Technical Service Information

HONDA CIVIC B4RA-M4RA-BMXA FAMILY WRONG GEAR STARTS-MULTIPLE SHIFT COMPLAINTS

Figure 1

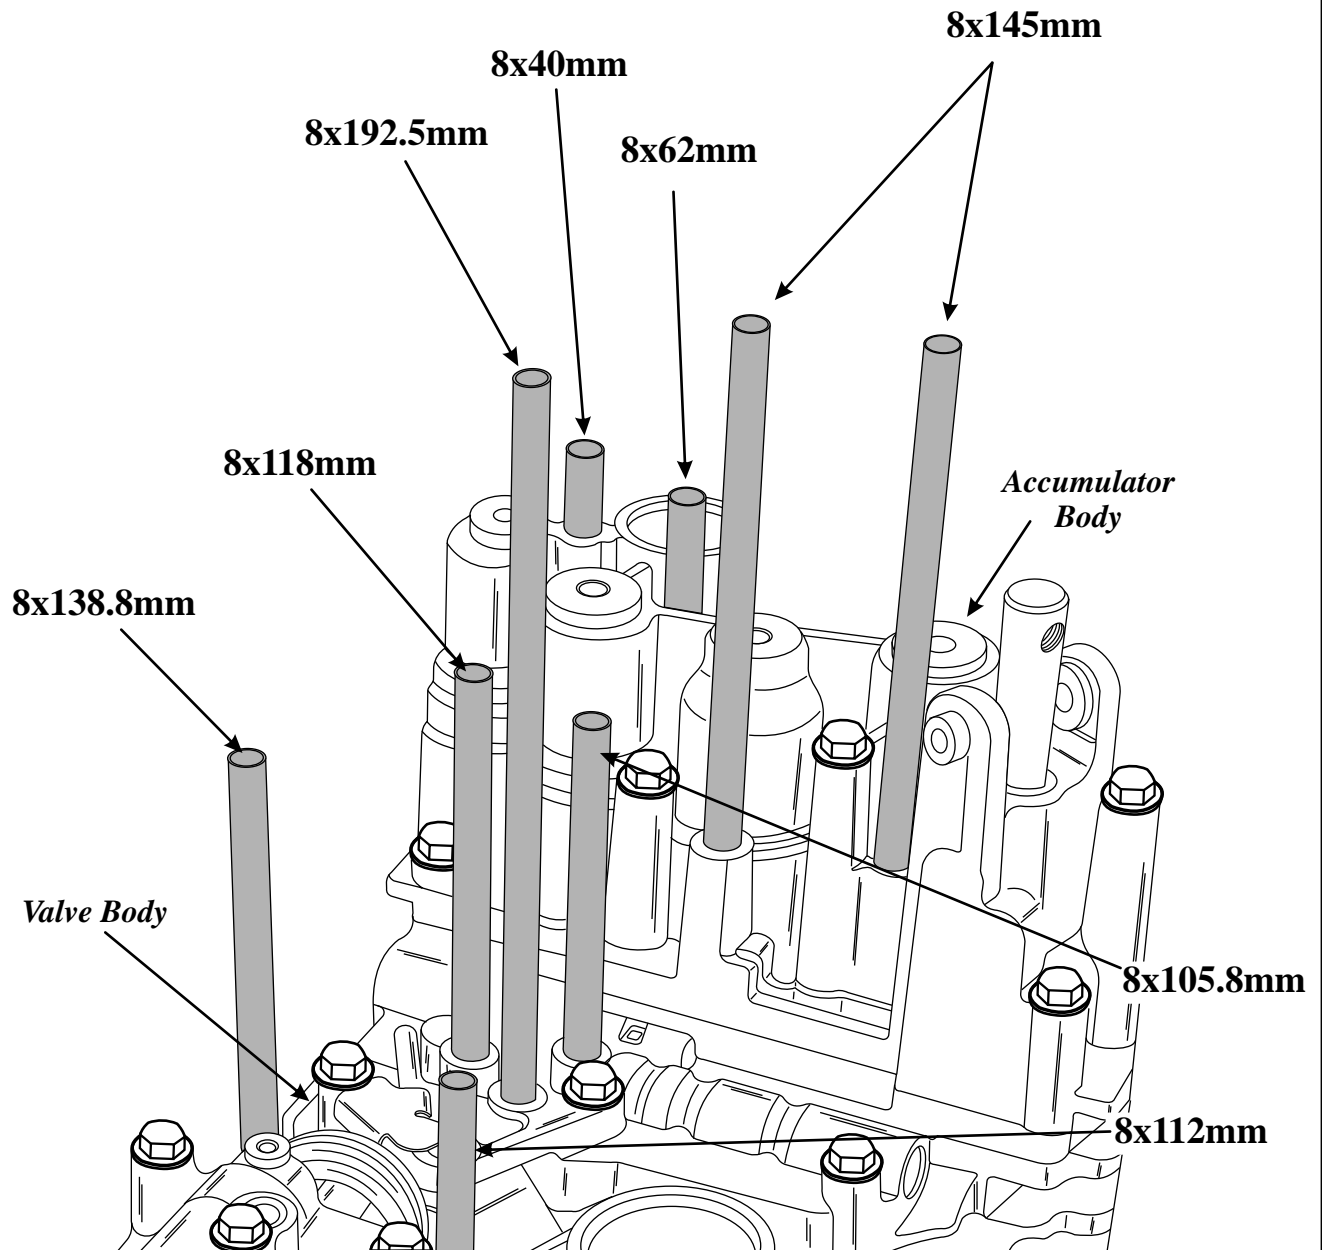
COMPLAINT: After overhaul, Honda Civics equipped with the B4RA, M4RA and or BMXA transaxle may exhibit wrong gear starts or multiple shift complaints.

CAUSE: The cause may be, that during overhaul of the valve body and re-assembly one or more of the feed tubes were placed into the wrong hole on the accumulator body or valve body, causing low modulating pressure , which is solenoid feed and or low clutch apply pressure to one or more of the clutch packs.

CORRECTION: To correct this condition, refer to Figure 1 and measure the feed tube lengths to ensure that they are going into the correct locations on the accumulator body and valve body.
